NRC-03-047

KEWAUNEE NUCLEAR POWER PLANT
DOCKET 50-305
LICENSE No. DPR-43
RESPONSES TO REQUESTS FOR ADDITIONAL INFORMATION REGARDING LICENSE
AMENDMENT REQUEST 193, MEASUREMENT UNCERTAINTY RECAPTURE POWER
UPRATE FOR KEWAUNEE NUCLEAR POWER PLANT

Responses to Requests for Additional Information Regarding LAR 193

Figures Supporting the I&C Responses
(Figure 1, Figure 2, and Drawing M-205)

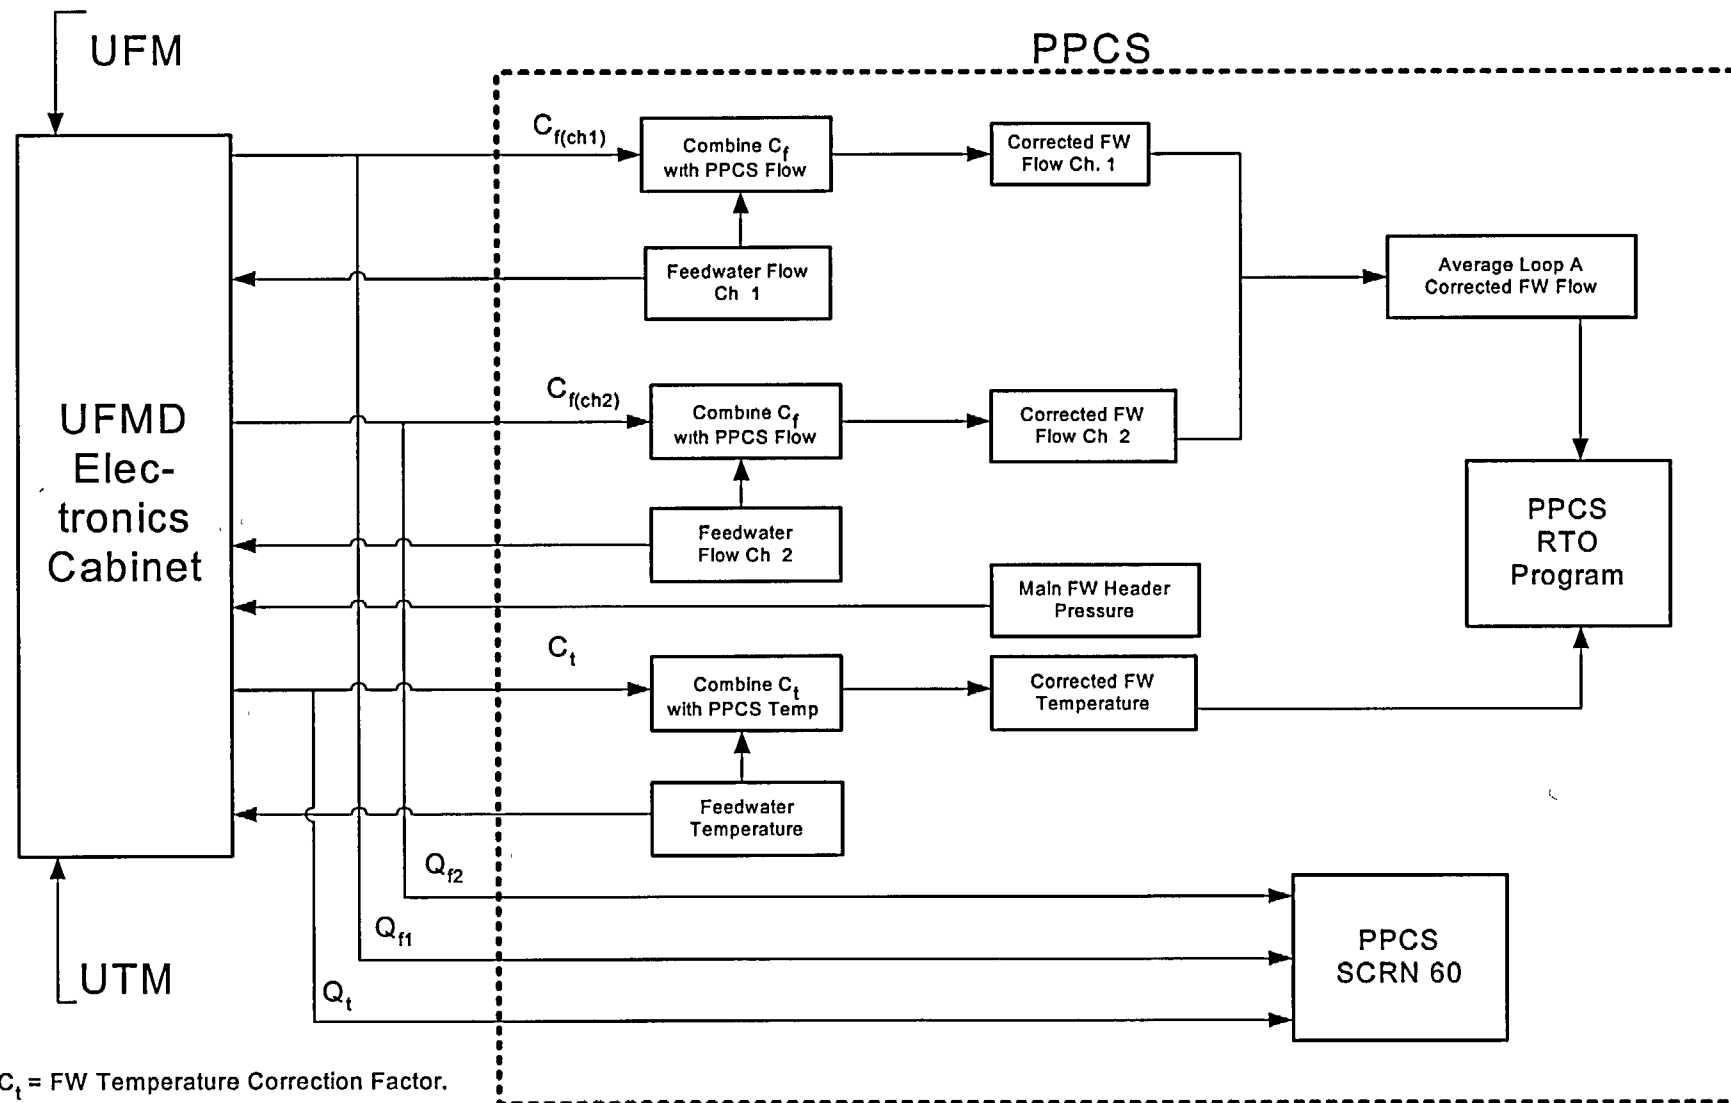
- 3. Provide a diagram similar to figures 2 and 3, but in more detail to identify calculations performed in the PPC or elsewhere, inputs to the PPC, and the communications links that exist. Also, provide the communications protocols for all inputs (e.g., analog-4-20 ma, EIA-232, 422). An engineering-grade drawing is preferable.**

4. **How will the PPC implement the different suite of inputs (UFM/UTM, UFM/resistance temperature device (RTD), venturi/RTD) consistent with the operational conditions of the UFM, UTMs and RTDs? Provide enough detail to aid the NRC staff in understanding how the operational modes are selected.**

- **A piping and instrumentation diagram showing the location of proposed UFM and UTM sensors and stand-alone UFM with detail to include the feedwater bypass and flow paths (an engineering drawing (with ISA type symbols) may be the best way to accomplish this). This drawing can then be used in the discussion.**

Figure 1 of attachment 6 to this letter shows the PPCS and UFMD electronics cabinet inputs and outputs and communication links that exist for the measurement of the feedwater flow and temperature for the A feedwater loop. The B feedwater loop communication inputs and outputs are identical. The interface between PPCS and the UFMD system is purely digital and contains essentially no error. The communication links are described in detail in the following paragraphs.

The PPCS interface data link provides data between the PPCS computer and the UFMD electronics cabinet. This data link provides the required plant data to the UFMD cabinet to allow the UFMD electronics cabinet to generate correction factors for feedwater flow and feedwater temperature for each steam generator. There are two individual feedwater flow correction factors calculated for each loop because there are two venturi flow channels on each feedwater loop. There is one temperature correction factor calculated for each feedwater loop. In addition, the interface data link returns the feedwater flow and temperature correction factors and UFMD status (quality) signals to the PPCS.

Note: that this screen structure provided in Figure 2 may change as the KNPP operators obtain experience with the system.

The location of the UFMDs on the A and B feedwater loops are upstream of the main feedwater regulating valves as shown on drawing M-205, "Flow Diagram Feedwater System," included in attachment 6 to this letter. The upper left hand quadrant of the drawing shows the feedwater flow paths to the A and B steam generators as well as the 24 inch, full flow bypass line (drawing coordinates A to C, 5 to 8). It is important to note that the temporary, stand-alone UFMD that was installed for calibration purposes on the permanently installed 24 inch, full flow bypass line is not shown on this drawing since it was a temporary installation and not a permanent modification to the plant. The temporary installation was for a one-time calibration of the B feedwater loop. That calibration is explained in the next bulleted item below. The temporary, stand-alone UFMD has already been removed.
